TECHNICAL INFORMATION DIGEST

TID 6-7

Revision: A
August 22, 1986

Multiple Device Controller (MDC), Serial Cable Paddle Connector Assembly and Communications (Comm) Adapter Configurations

Figure 1 MDC, Paddle Connector and Communications Adapter Compatible Configurations

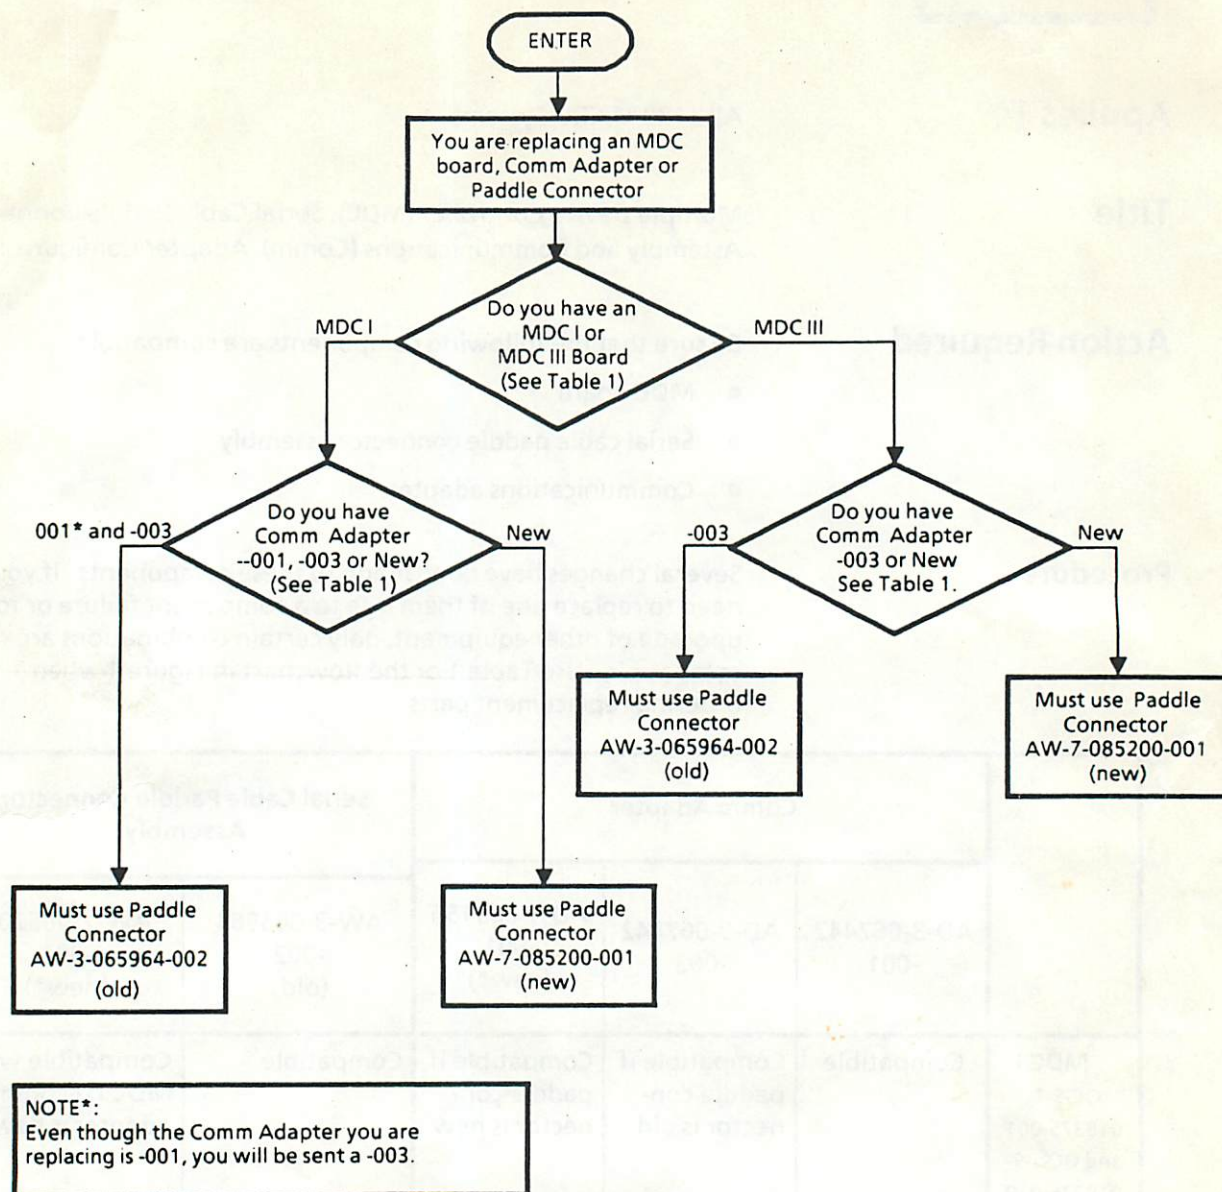
Several changes have been made to these components. If you need to replace one of them due to a component failure or for an upgrade of other equipment, only certain combinations are compatible. Use Table 1 or the flowchart in Figure 1 when ordering replacement parts.

Be sure that the following components are compatible:

- MDC board
- Serial cable paddle connector assembly
- Communications adapter.
